# Access Compliance Report

## Public Rights-of-Way

Intersection ID: 14710	Main Street: LYNDHURST_AV	Cross Street: MCDONALD_AV	Location: S
ADA ID: AD75CC889DD7	Ramp Type: Perp	Initial Pass/Fail: Fail	Overall Compliance: No
		Severity Score: 12.5

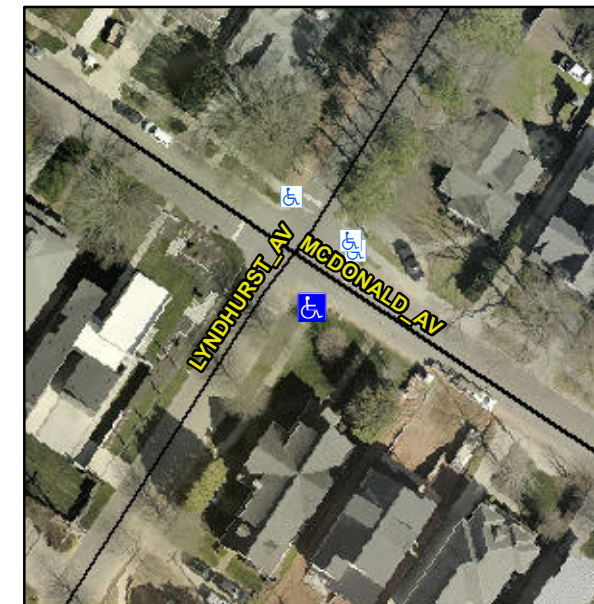
**Not Found, R304.2.2**

Compliance	Description	Data	Compliance	Description	Data
N/A	Ramp Length (in)	106.0	No	Ramp Slope (%)	11.1
Yes	Ramp Width (in)	55.0	Yes	Ramp XSlope (%)	1.3
N/A	Flare Type LT	N/A	N/A	Flare Type RT	N/A
N/A	Flare Slope LT (%)	N/A	N/A	Flare Slope RT (%)	N/A
N/A	Flare Traversable LT?	N/A	N/A	Flare Traversable RT?	N/A
N/A	Landing Length (in)	N/A	N/A	DWS Provided?	N/A
N/A	Landing Width (in)	N/A	N/A	DWS Contrast?	N/A
N/A	Landing Slope (%)	N/A	N/A	DWS Length (in)	N/A
N/A	Landing X Slope (%)	N/A	N/A	DWS Full Width?	N/A
N/A	Landing Curb? (Y/N)	N/A	N/A	DWS Offset (in)	N/A
N/A	Shared Landing?	N/A			
N/A	Gutter Ponding?	N/A	N/A	Gutter Slope (%)	N/A
N/A	Gutter Lip Ht (in)	N/A	N/A	Gutter X Slope (%)	N/A
N/A	Painted X Walk1?	No	N/A	Painted X Walk2?	N/A
	X Walk 1 Direction	To NE		X Walk 2 Direction	N/A
N/A	X Walk 1 Width (in)	N/A	N/A	X Walk 2 Width (in)	N/A
	X Walk 1 Slope (%)	0.8		X Walk 2 Slope (%)	N/A
	X Walk 1 X Slope (%)	0.0		X Walk 2 X Slope (%)	N/A

**Remove & Replace Entire Ramp.**
